Annex E HVDC Converter Transformers and Smoothing Reactors Subcommittee

**October 15, 2018, 3.15 pm
Jacksonville, Florida, USA**

E.6.1 WG IEEE P1277 - Dry-Type and Oil-Immersed Smoothing Reactors and Dry-Type Converter Reactors

E.6.1.2 Survey of Annexes.

Annex A - Application of LCC HVDC smoothing reactors - informative

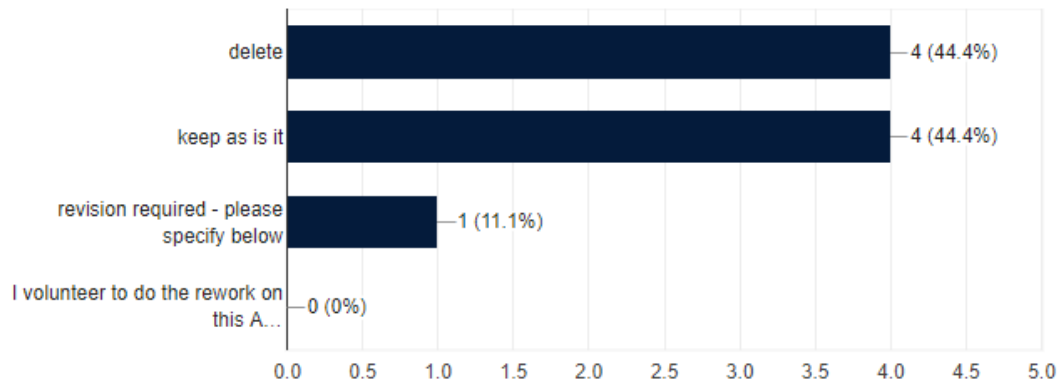
Since most of the annex relates to system design, I would agree that it is not needed.

Delete but address topics of Annex A in the main text with references to suitable literature provided under bibliography.

Preliminary decision: Delete since it mostly covers system design aspects. Klaus Pointner will check if there is something that we should keep and in that case copy it into the main text of the standard.

Annex B - Construction of oil-immersed smoothing reactors - normative

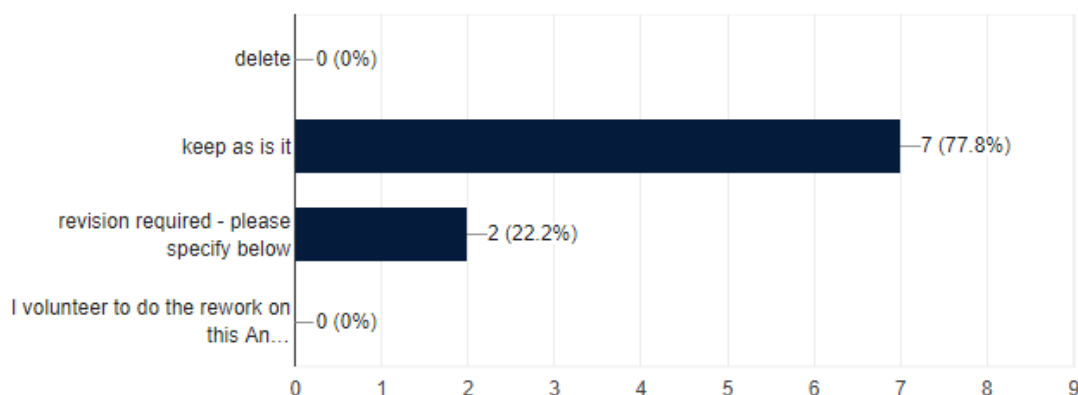
Everything is similar to converter transformers, return the text in the main text, replace most of it by a simple reference to IEEE C57.12.00 and just keep specificities to oil-immersed smoothing reactors (like current transducers)

The information is almost entirely general and not SR specific. Only the hint in B.3.1.2 must somehow be mentioned in the standard - all other stuff is useless.

comment: so few SMR are oil immersed nowadays, perhaps not worth the effort to maintain details about construction that will likely evolve over time

Annex C - Construction and installation of dry-type air-core smoothing reactors for HVDC application - informative

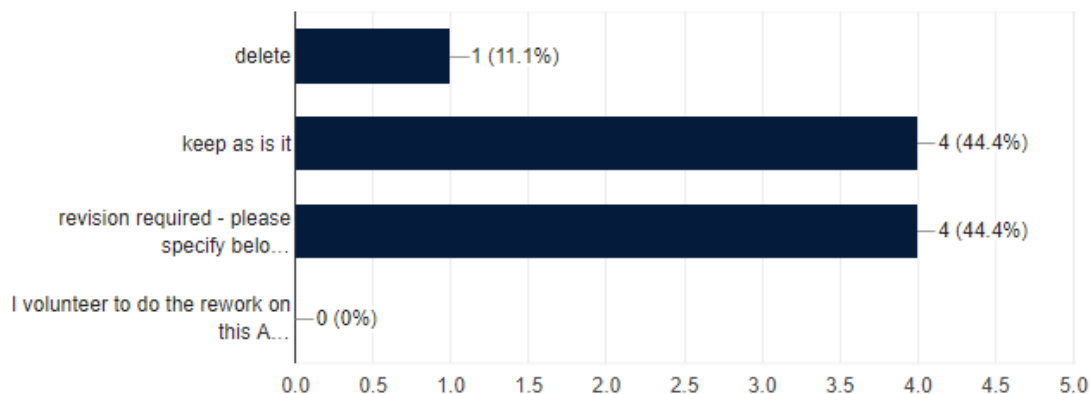
The content should be reduced. It contains a lot of considerations for the system design.

As the section is not too long and most SRs are dry-type, the Annex can be kept but reviewing / improvement of the content is required.

possibly address black spot phenomena ? for discussion

Preliminary decision: Keep. Volunteers are requested for review. Black spot issues should be addressed.

Annex D - Short-circuit test capability - informative

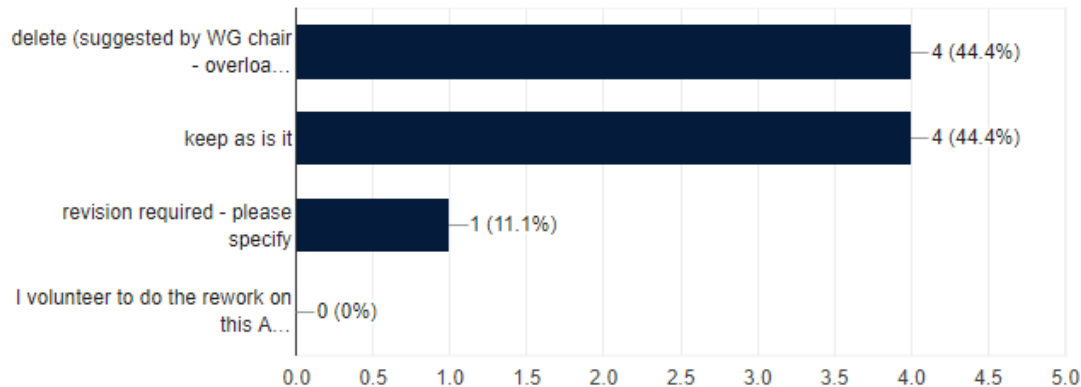
D.2.1, 2dn para, it says "around 132000 MVA" should it be "around 13200 MVA"?
Otherwise it seems to be in good shape.

Keep it as modified in D4

I do not find D4 - sorry. An informative good Annex on SC testing is helpful to have.

minor revision as already outlined

Preliminary decision: Keep but revised. Draft 5 is updated. WG members can review this Annex now.

Annex E - In-service overloading of HVDC smoothing reactors - informative

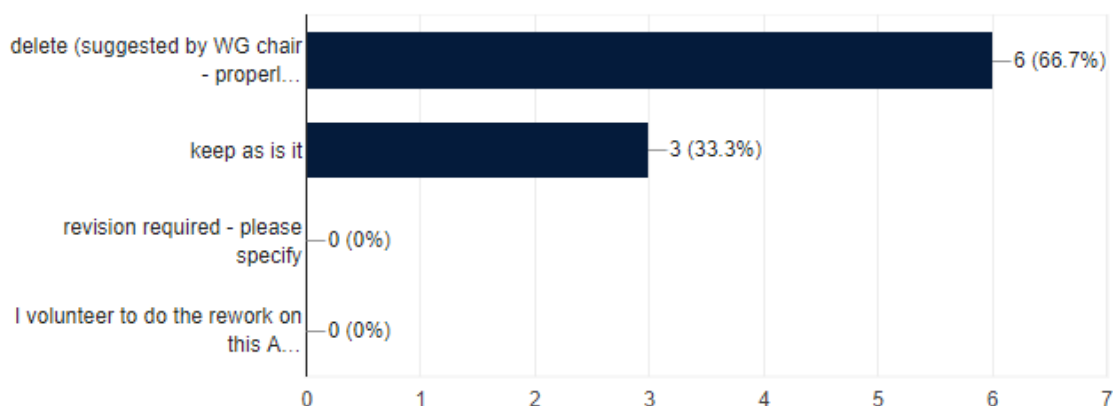
I think that we should keep the annex but reduce it. Overload is often of very high importance in HVDC projects and should therefore be handled in some way by the manufacturers of some main equipment, e.g. design for the overload or verify that it is ok (within the design). Perhaps we should remove equations and just keep some main topics regarding overload.

This annex gives important material and should be kept

Delete without replacement. Just mention in main text that overload conditions must be specified.

Preliminary decision: Keep but reduce the content. Overload is often a very important topic for an HVDC project. The examples are good to show end users typical kind of overloads.

Annex F - Smoothing reactors used in voltage source converters (VSC) HVDC schemes - informative

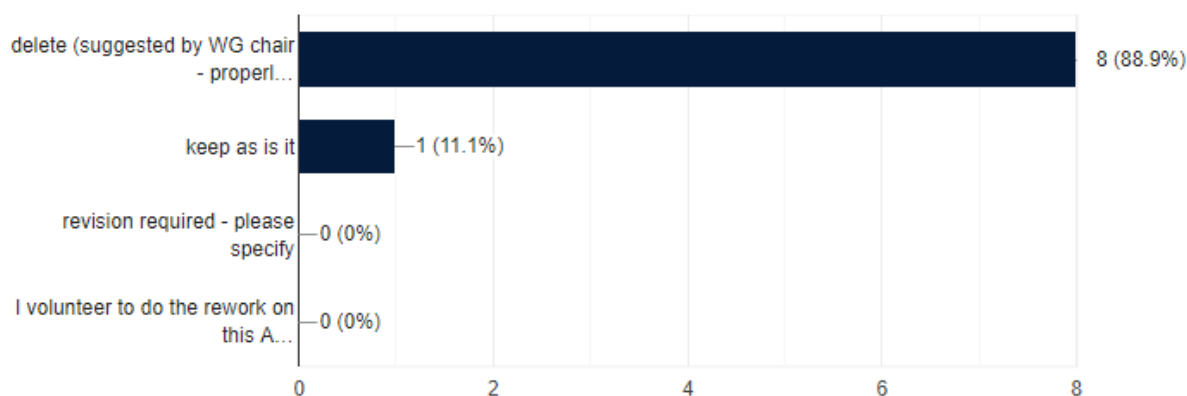
This technology is new, keep it for the next edition. Could be deleted later.

Preliminary decision: Delete. Smoothing reactors for VSC are handled in the same way as smoothing reactors for LCC.
